ITEM E1 - ALASKAN WILDWOOD EAST

KPB 2021-126
S13 T04S R14W
Nikolaevsk

KPB File No.	2021-126
Plat Committee Meeting:	April 11, 2022
Applicant / Owner:	Joe Balyeat of Bozeman, MT
Surveyor:	Andre Kaeppele, Buk Saliz / Fixed Height LLC
General Location:	Nikolaevsk / Anchor Point APC

STAFF REPORT

PRELIMINARY PLAT

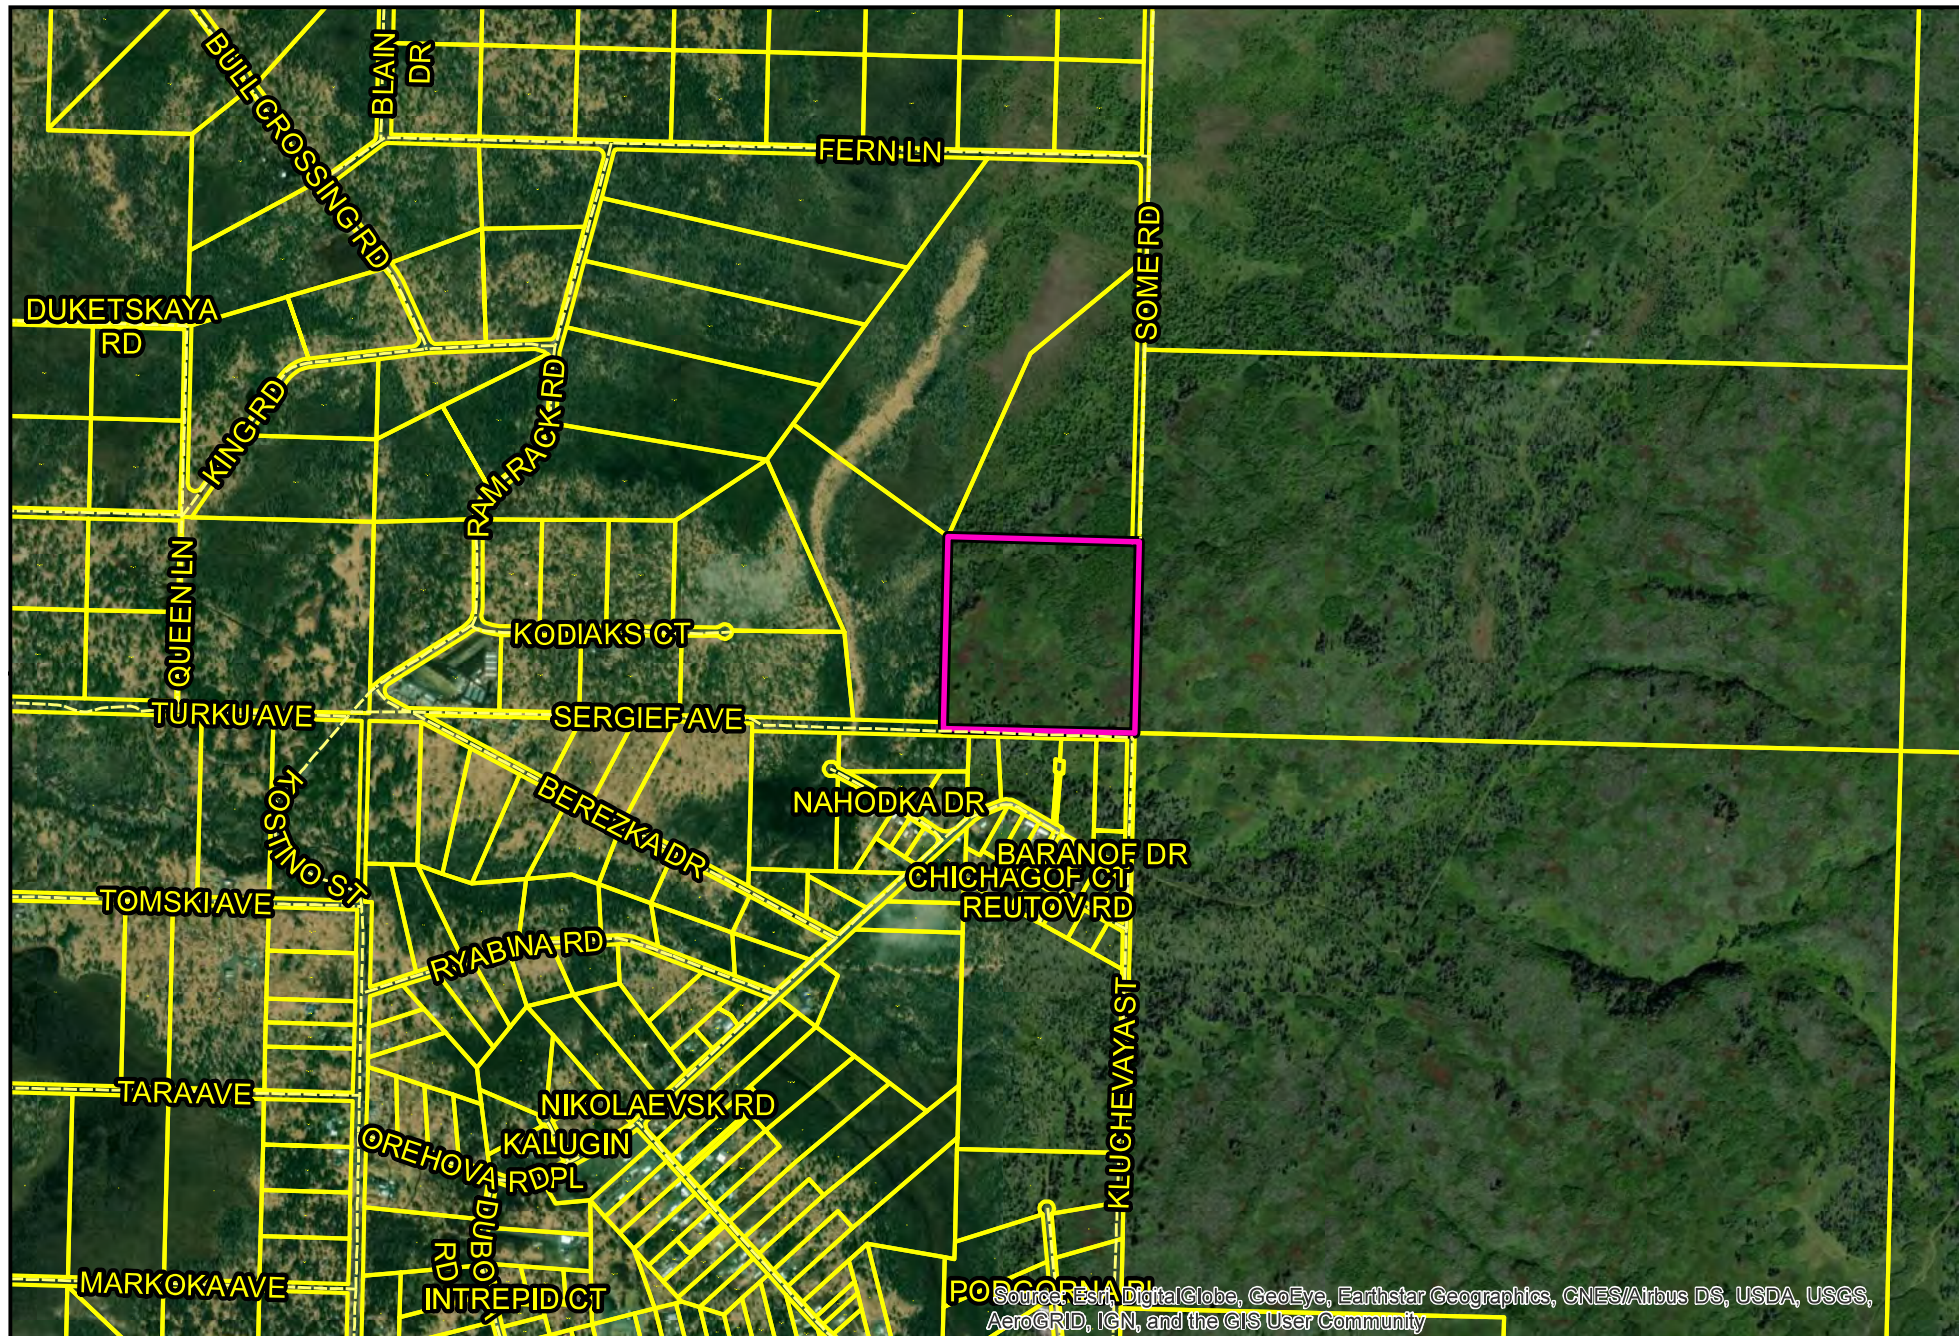
Staff Discussion: The Kenai Peninsula Borough Plat Committee heard and approved the preliminary plat at the September 27, 2021 meeting. A final was received for review on November 8, 2021 with the same design. Due to the terrain, centerline profiles were requested to determine if slope easements would be required. The surveyor determined, due to the terrain, the road needed to be slightly adjusted. The final submitted on February 22, 2022 showed a minor design change. There are still eight lots but the configuration and the road design have slightly changed. The design is keeping the lots above 200,000 square feet so that soils analysis report is not required. The new design has resulted in one of the lots not complying with the 3:1 depth to width requirements.

5. KPB Code requires a ratio of 3:1 for the depth to width of lots.
6. Due to the change in design, the ratio for Lot 4 is 3.3:1.
7. There are some low wet lands present in the western portion of Lot 4.
8. The change in design can be attributed to the terrain and the need to place the right of way dedication in the best location.
9. The road has been shifted to the east to provide a better connection to Sergief Avenue.
10. Slope easements are proposed and have been reviewed and approved by the KPB Roads Department.
11. The redesign changed from four lots on each side of the dedication to five on one side and three on the other.

Approval will require a new plat note for the exception granted in addition to any corrections noted by staff during their final review.

Staff recommendation: place notes on the final plat indicating any exceptions granted by the Plat Committee with the meeting date and provide the correct Wastewater Disposal note.

ROAD PLAN AND PROFILE OF

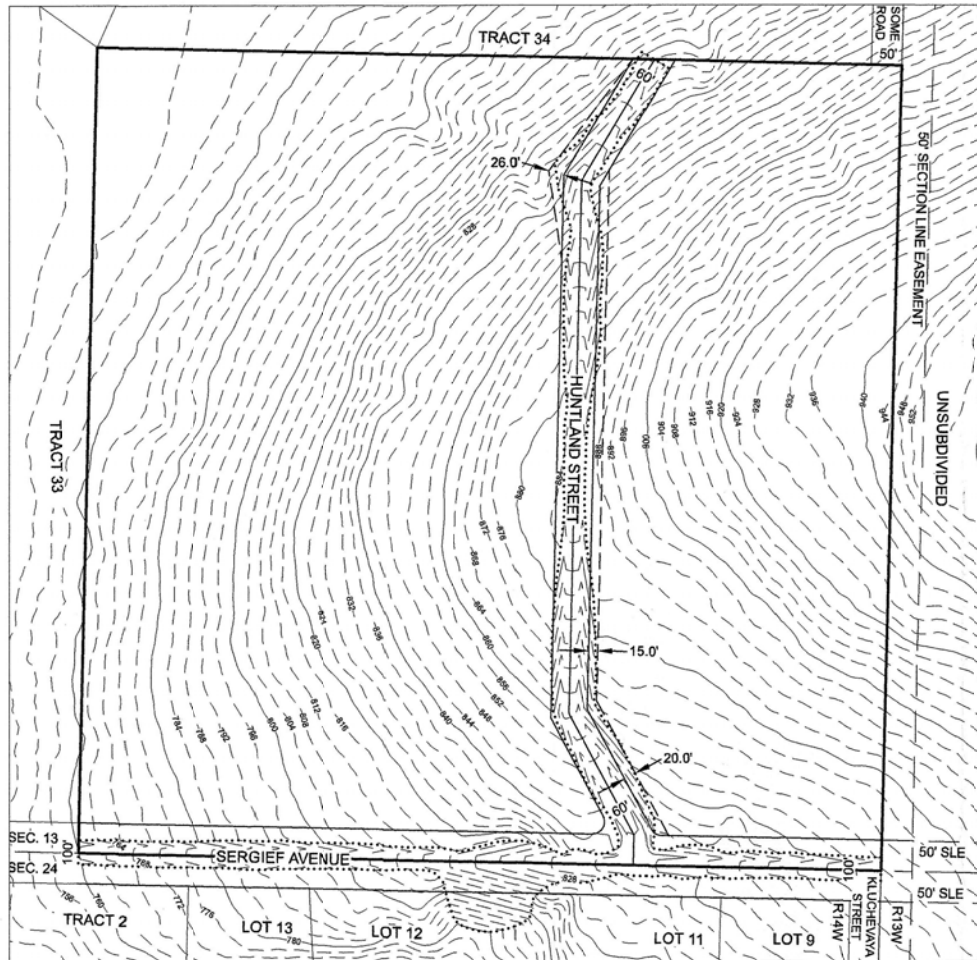
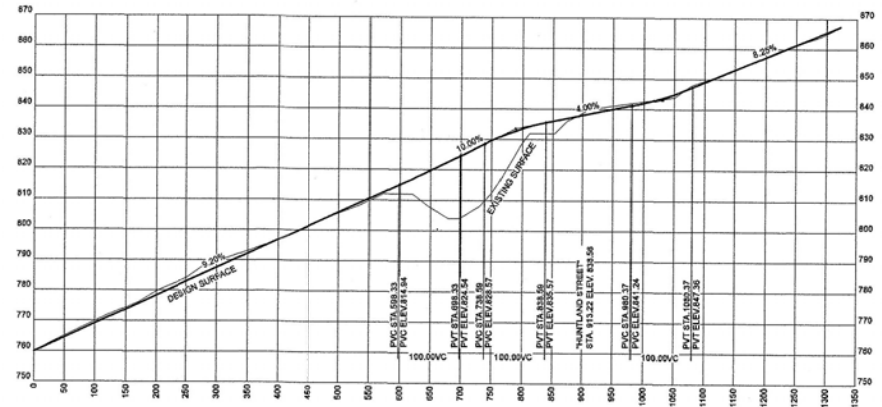
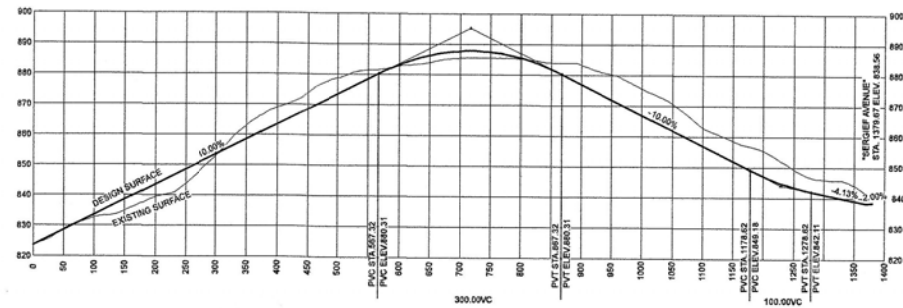
Staff recommendation: *If necessary, provide lateral support (slope) easements for any roadways that are affected by steep terrain so that a road way can be constructed with no more than a 10% grade. Provide road plans with centerline profiles and cross sections to show the roadway limits.*

Staff recommendation: *Provide road plans with centerline profiles and cross sections to show the roadway limits.*

Alaskan Wildwood Phase 1
KPB File 2021-126

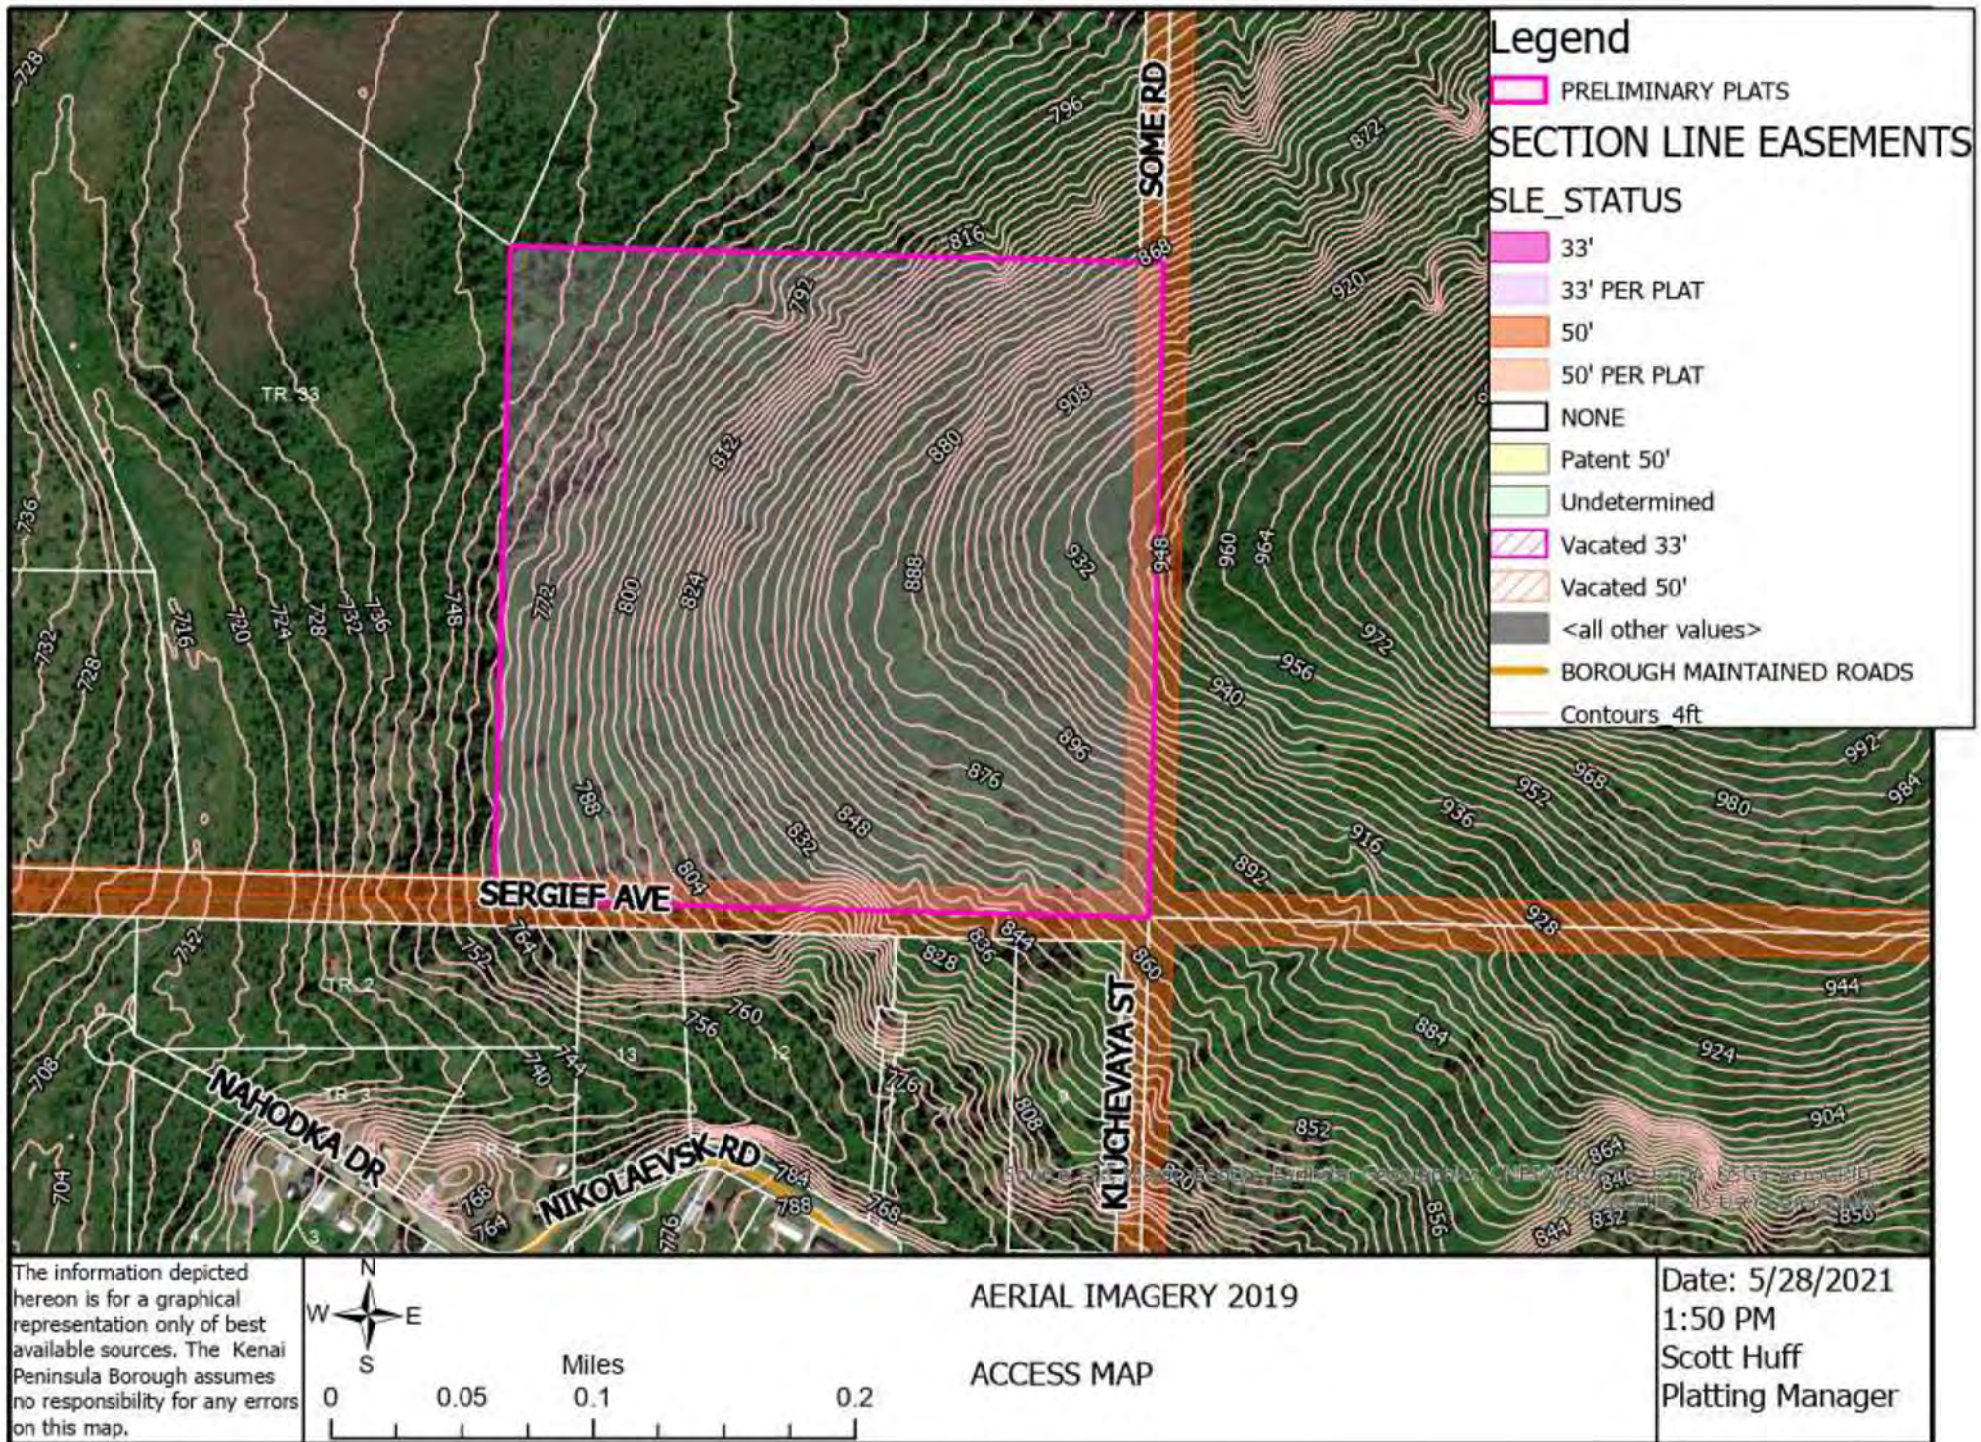
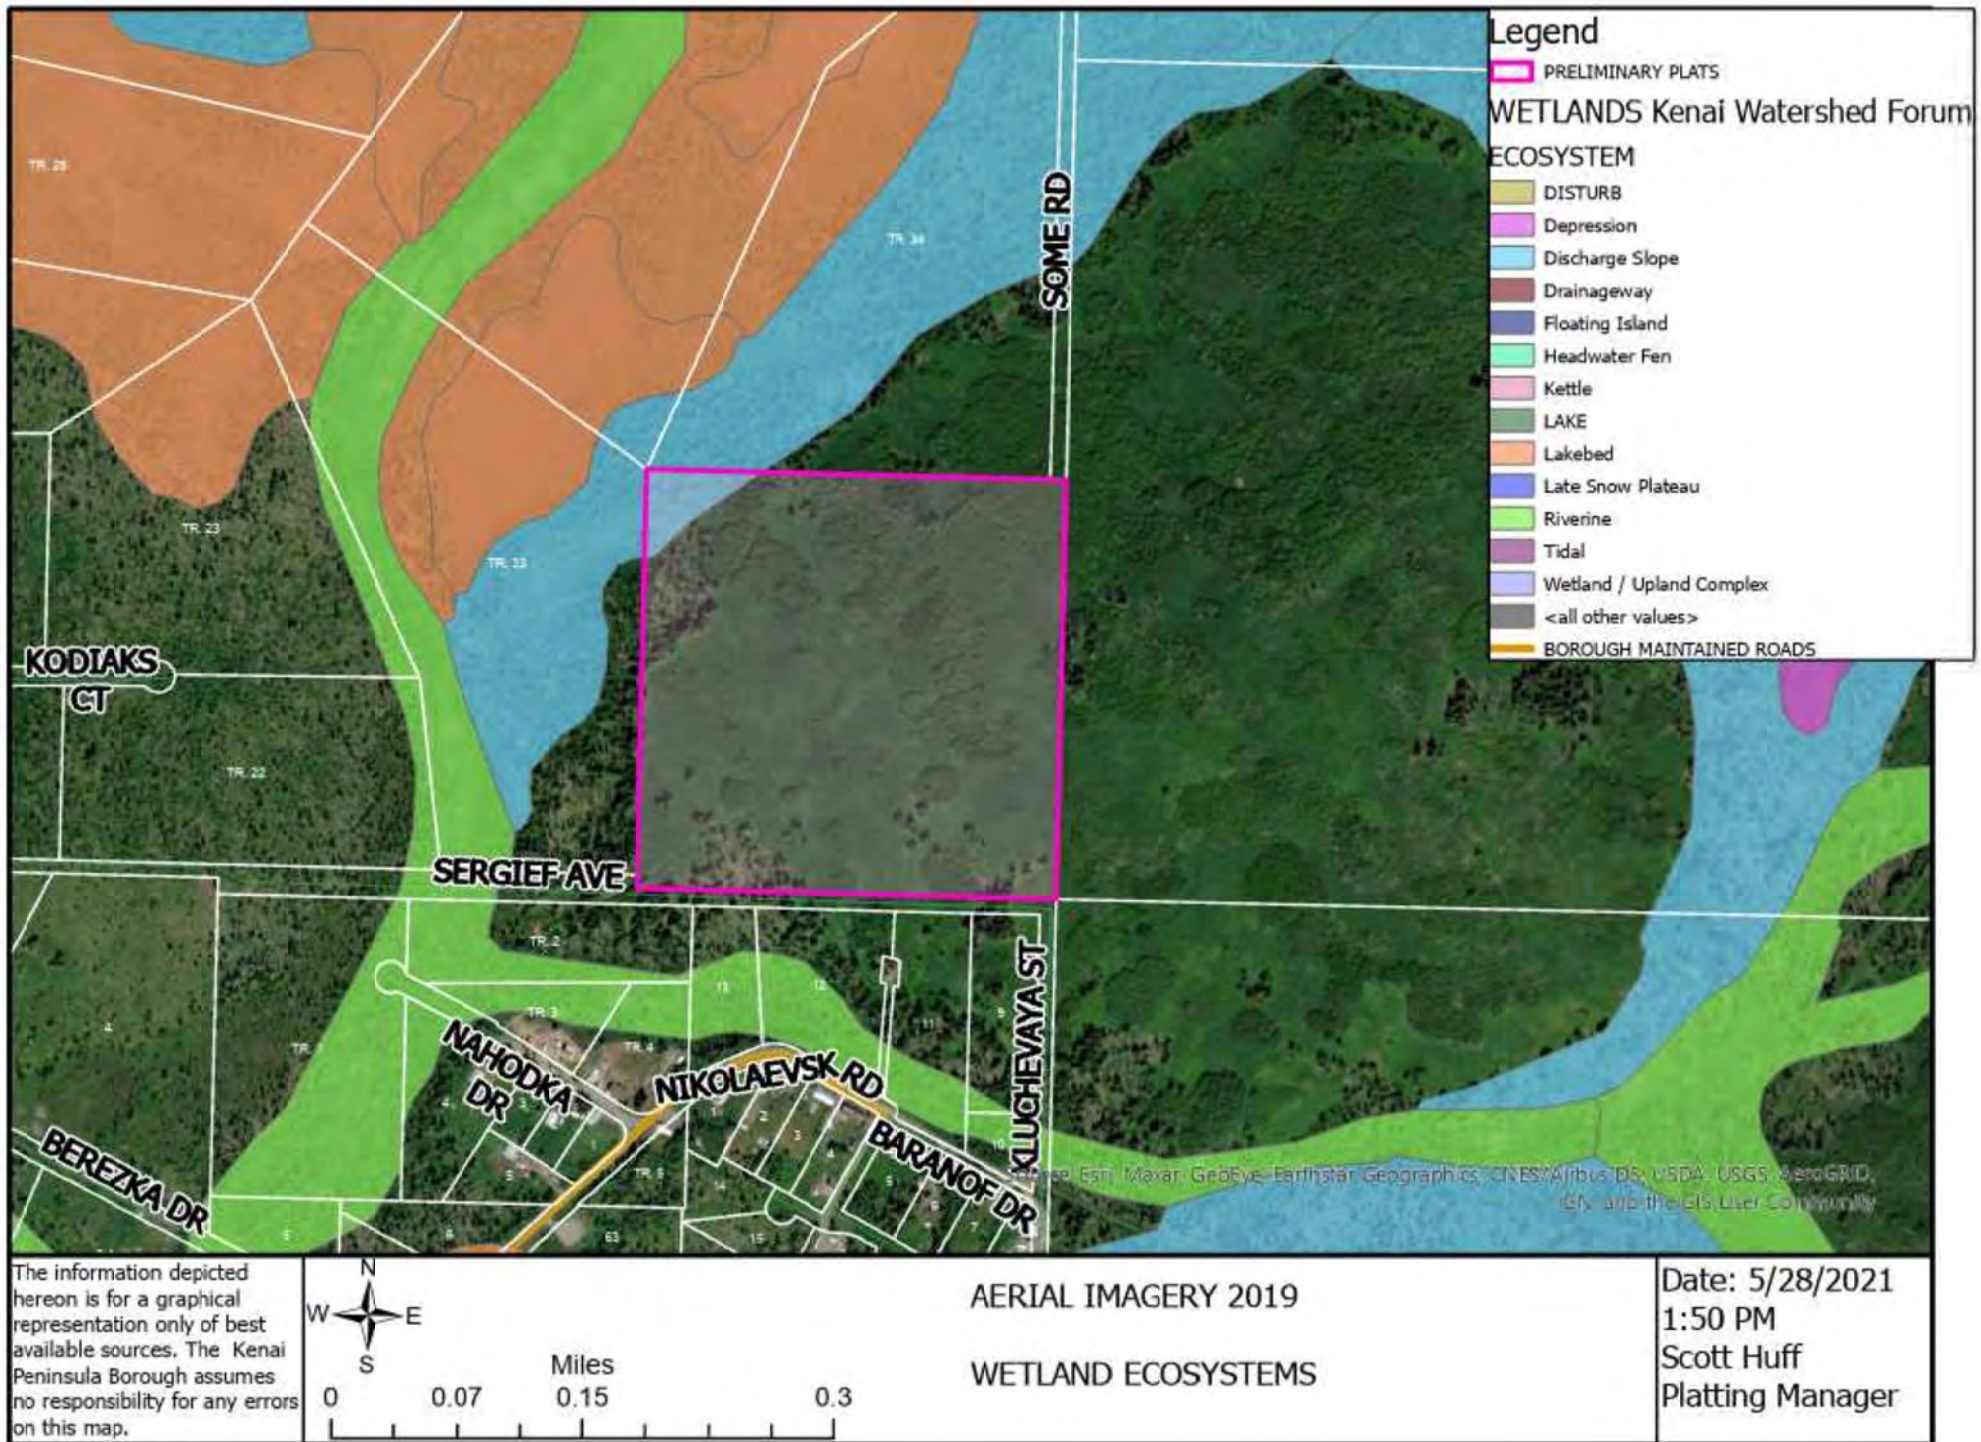
- Update the subdivision name to Alaskan Wildwood Subdivision. Phase is a designation used for a portion of a larger approved plan where portions are finalized at different times.

- Provide the KPB file number (2021-126) near or within the title block.
 - Within the title block remove the reference to Document No. 2019-002734 as that is a deed and not a document that created the parcel of land.

- Provide the owners name and mailing address within the title block.
 - Update the sheet to 1 of 1.
- C. The location, width, and name of existing or platted streets and public ways, railroad rights-of-way, and other important features such as section lines or political subdivisions or municipal corporation boundaries abutting the subdivision;

- Staff recommendation:** Label all section line easements within and abutting the subdivision such as the one within Section 19. Provide a street name label and right of way width for Kluchevaya Street.

Staff recommendation: *The hatching used on the plat is typically used to depict vacations. No hatching is required for ROW dedications. Provide labels that state ROW being dedicated this plat. Update to the subdivision boundary to show the parent parcel as the boundary.*

Staff recommendation: *Per KPB GIS data, the northwest corner may contain wetlands. Verify during the field survey and depict and label any low wet areas that affect the subdivision.*

Staff recommendation: *Provide a minimum 30 foot dedication along the eastern boundary for the extension of Some Road.*

Staff recommendation: *Within the drawing, depict and label the 20 foot building setback.*

Plat note 1 is duplicated within plat note 3. Remove plat note 1 or remove that portion from plat note 3.

Plat note 6 refers to a registered trademark. Staff is unsure as to the intent for this note, as there does not appear to be any reference outside of the plat note to Alaska Wildwood Ranch. Remove plat note 6 from the final plat.

Staff recommendation: *Provide all survey marker cap information for found monuments. Comply with 20.60.200*
